**EDWIN I. HATCH NUCLEAR PLANT, UNIT NOS. 1 AND 2
REQUESTS FOR ADDITIONAL INFORMATION (RAIs),
FOURTH 10-YEAR INTERVAL INSERVICE INSPECTION PROGRAM**

**EDWIN I. HATCH NUCLEAR PLANT, UNIT NOS. 1 AND 2
REQUESTS FOR ADDITIONAL INFORMATION (RAIs),
FOURTH 10-YEAR INTERVAL INSERVICE INSPECTION PROGRAM**

Edwin I Hatch Nuclear Plant –Units 1 and 2
NRC Request For Additional Information
Fourth 10-Year Inspection Interval

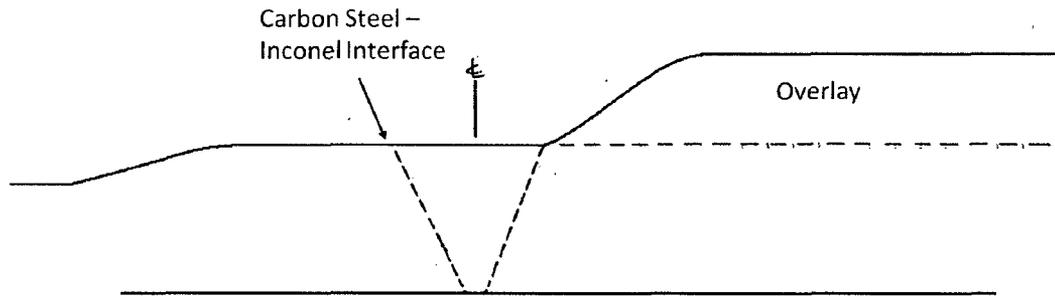
Please provide a more legible copy of Figure 1 on page 4 of 5.

Relief Request RR-47, dated July 10, 2006, reports 75% coverage on this same weld when it was examined prior to the implementation of Appendix VIII and the Performance Demonstration Initiative (PDI) Program. The total coverage for this weld exam included examination from the Inconel side of the weld, through the weld overlay. Specifically, the examination through the weld overlay was performed using an automated system utilizing a 60-degree refracted longitudinal wave search unit. No limitations due to the overlay were noted in the relief request. Additionally, no unacceptable indications in the weld were reported. In light of the apparent successful examination of the required weld volume (lower 1/3T) through the weld overlay in the 3rd 10-Year ISI interval, please justify the omission of this (supplemental) exam for 4th 10-year ISI interval. The NRC understands that there are currently no PDI-qualified techniques to perform the examination of the lower 1/3T through a weld overlay.

Please explain why the weld overlay does not cover weld 2B21-1FW-12AA-8.

Figure 1 was replaced by a new Figure 1, as shown below.

As depicted in revised Figure 1, the configuration for weld 2B21-1FW-12AA-8 consists of a tapered area to the left side of the weld, a relatively flat area from the taper to overlay, and a full-structural weld overlay over adjacent weld 2B21-1FW-12AA-9. The 3rd 10-Year ISI interval examinations were performed prior to Appendix VIII, Supplement 10 requirements which were not required to be met until November 22, 2002. These pre-Appendix VIII examinations met requirements of the 1989 Edition of Section XI (no addenda). Scans were performed from the tapered area to the left side of the weld, from the flat surfaces, and from the overlay side of the weld. The only area not scanned was the overlay taper.

Weld 2B21-1FW-12AA-9 was overlaid in 1991 after indications were found during the non-destructive (NDE) examination. Adjacent weld 2B21-1FW-12AA-8 was not overlaid because:

1. Weld 2B21-1FW-12AA-8 had no recordable indications during the 1991 examinations.
2. Using the non-Appendix VIII NDE techniques (as discussed in RAI 2), there were no significant coverage limitations of weld 2B21-1FW-12AA-8 expected to be present during future examination as a result of the adjacent overlay. This was later demonstrated during the 1994 and 1997 outages where coverage was 100% using non-Appendix VIII techniques.
3. It was determined that the appropriate mitigation approach would be to use the mechanical stress improvement process (MSIP). MSIP was performed in 1994.
